Title - Sujet Fuel Storage Tank Removal Fuel Storage Tank Removal	
Solicitation No. - N° de l'invitation EP916-212422/A	Amendment No. - N° modif. 004
Client Reference No. - N° de référence du client 20212422	Date 2021-06-25
GETS Reference No. - N° de référence de SEAG PW-\$\$\$FG-374-80077	
File No. - N° de dossier fg374.EP916-212422	CCC No./N° CCC - FMS No./N° VME
Solicitation Closes - L'invitation prend fin at - à 02:00 PM Eastern Daylight Saving Time EDT on - le 2021-06-29 Heure Avancée de l'Est HAE	
F.O.B. - F.A.B. Plant-Usine: <input type="checkbox"/> Destination: <input type="checkbox"/> Other-Autre: <input type="checkbox"/>	
Address Enquiries to: - Adresser toutes questions à: Vani-Machado, Alba	Buyer Id - Id de l'acheteur fg374
Telephone No. - N° de téléphone (873) 355-4048 ()	FAX No. - N° de FAX () -
Destination - of Goods, Services, and Construction: Destination - des biens, services et construction:

Amendment 004 is issued for the following:

(1) Bidder Question & Answer

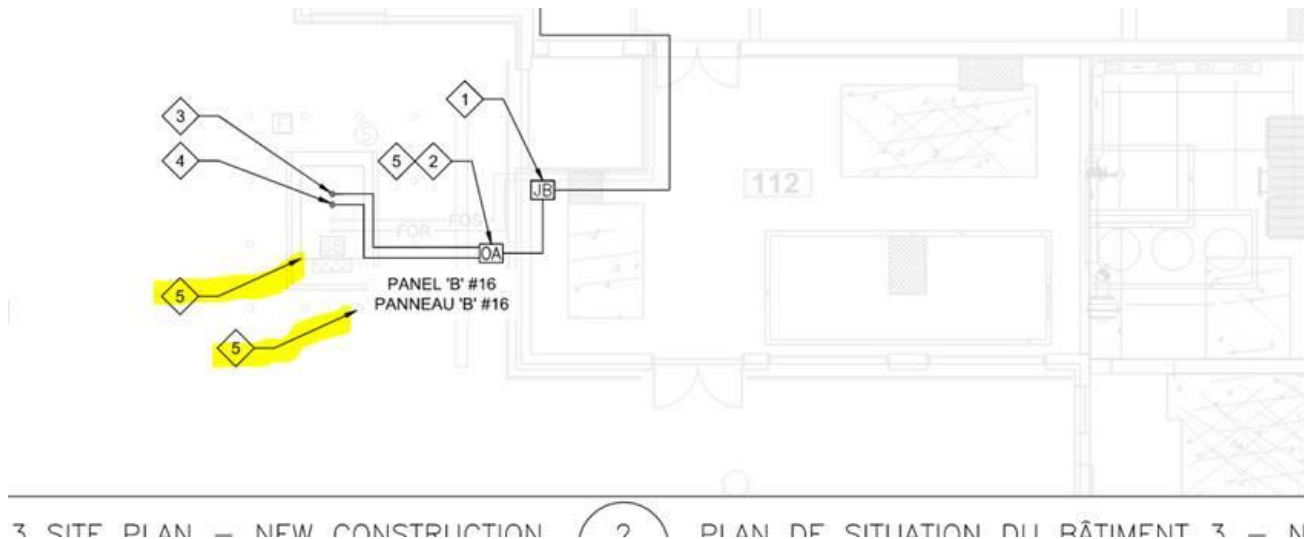
With reference to the Survey report on designated substance and hazardous building, some points are not perfectly clear.

Could you please confirm that all pipes to be dismantled are not insulated with asbestos?

Also could you please confirm that the existing wall penetration are to be reused? If not, does the wall where new penetration are to be created contain asbestos or any other designated substance?

ANSWER # 04: Please refer to the designated substance survey. The fuel piping does not have any insulation but may contain lead paint. The existing wall penetration is not to be reused. The new penetration area may contain asbestos and lead paint.
